Project	IEEE 802.16 Broadband Wireless Access Working Group < http://ieee802.org/16 >	
Title	802.16g Figure 1 issues	
Date Submitted	2005-03-16	
Source(s)	David Johnston Intel Corporation	Voice: (503) 264 3855 Email: dj.johnston@intel.com
Re:	Call for comments	
Abstract		
Purpose	This document attempts to clarify what delta changes 802.16g should make to 802.16-2004 (as amended by succeeding amendments)	
Notice	This document has been prepared to assist IEEE 802.16. It is offered as a basis for discussion and is not binding on the contributing individual(s) or organization(s). The material in this document is subject to change in form and content after further study. The contributor(s) reserve(s) the right to add, amend or withdraw material contained herein.	
Release	The contributor grants a free, irrevocable license to the IEEE to incorporate material contained in this contribution, and any modifications thereof, in the creation of an IEEE Standards publication; to copyright in the IEEE's name any IEEE Standards publication even though it may include portions of this contribution; and at the IEEE's sole discretion to permit others to reproduce in whole or in part the resulting IEEE

2 Proposed Stack Layering in DOC 010

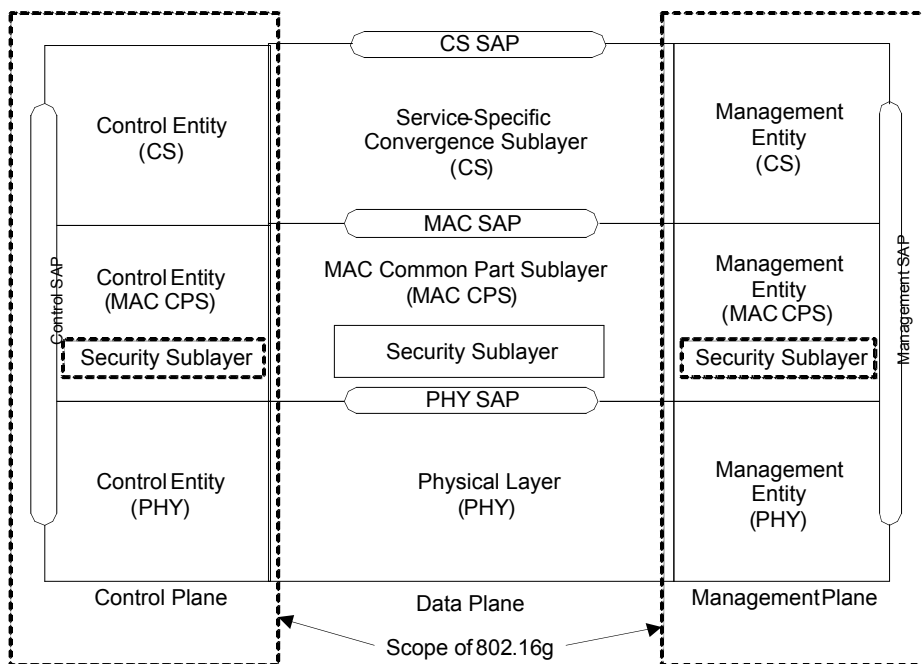
This diagram does not describe the diagram that 802.16g would insert into 802.16-200x. Taking 802.16-2004 as an example, the diagram describes data and management planes, data plane interfaces and outlines the scope of 802.16-2004 as being limited to the data plane.

The diagram above separates out control and management planes. This may be an appropriate separation of function in 802.16g, however this separation of function is not expressed in the base document. As such, the control/management split may be considered a hierarchical split underneath the management plane as expressed in the base document.

The scope of 802.16g in the above diagram is limited by the PAR to management procedures and logically this would correspond to the dotted rectangle on the right hand side of the above diagram.

Replace figure 1 with:

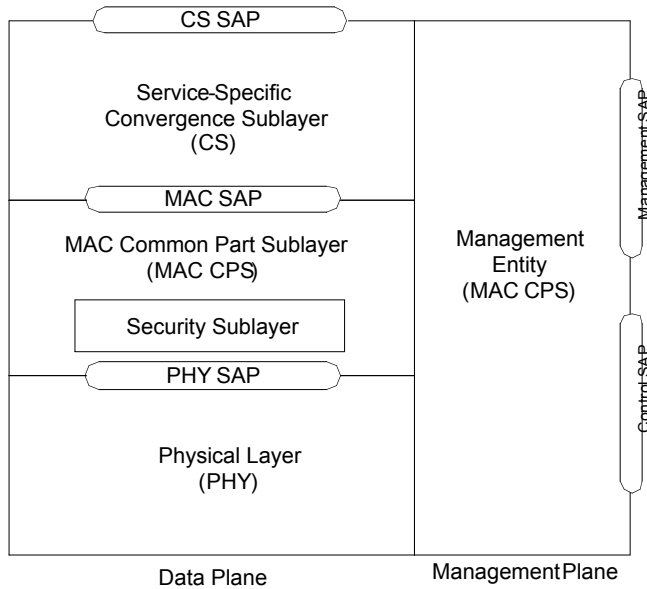
802.16g will create an amendment that leads to a specification with a scope encapsulating both data and management planes.

The internal separation of MAC, PHY and CS does not map to the data plane separation and implies that separate control and management SAPs for each layer are required.

Accordingly, the stack diagram in Doc 05-010r1 is appropriate for either informative material describing the scope and internal structuring of 802.16g, however the actual diagram in 802.16 that is proposed as a replacement for figure 1 in the base 802.16 would map this structure into the base document’s diagram.

This diagram maps both interfaces into the management plane in the base standard, while they may still hook into the separate control and management entities expressed in 802.16g.

The dotted line scope delimiter is removed, since the scope of the amended specification will encapsulate the whole of the stack, even though the scope of 802.16g is limited to the management side.

The dotted line separation of security management appears superfluous, given that the security management protocols obviously appear in the management plane along with all the other management protocols. With the network model and SAPs proposed, we might expect primitives related to security to appear on one of the management SAPs and map to the interface to the ASA in the proposed network model. Accordingly in the proposed diagram there is no separation of the security management entity.

[Replace figure 1 with the following diagram]

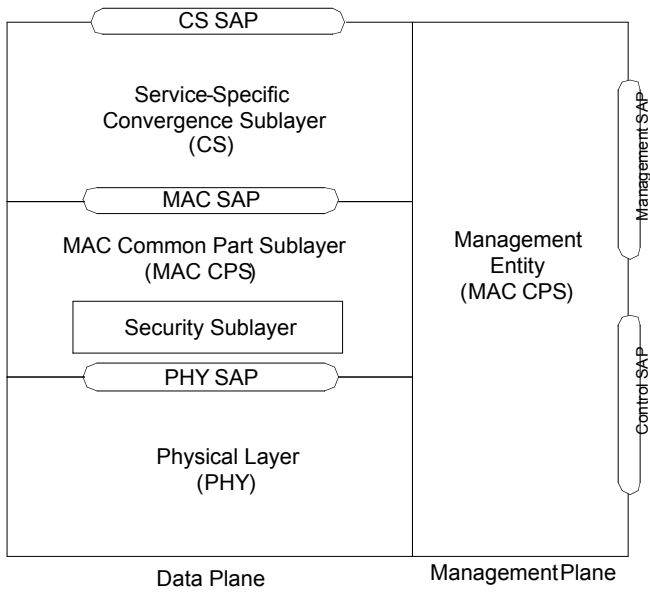
Option 1

14.4.1.1.2.1 Control SAP

- AAA server signaling (E.G. EAP payloads)

[Replace figure 1 with the following diagram]

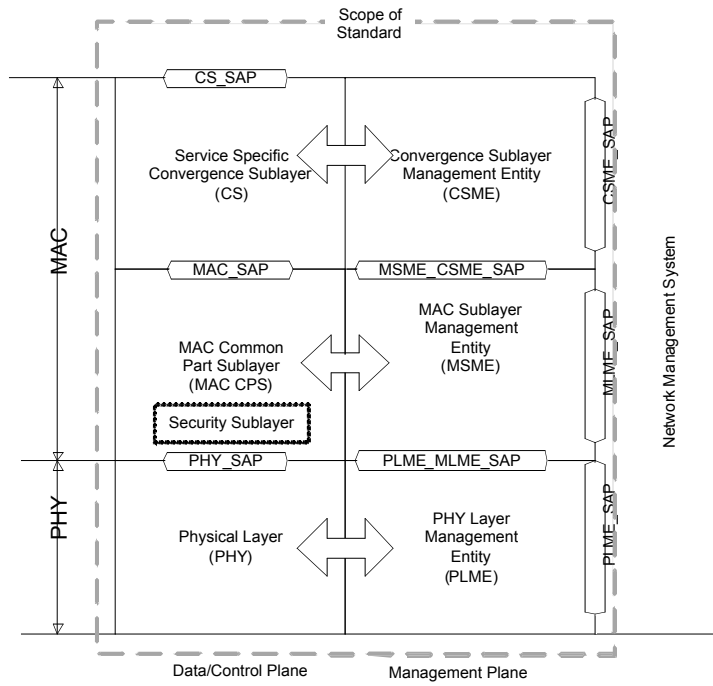
Option 2

14.4.1.1.2.1 Control SAP

- AAA server signaling (E.G. EAP payloads)
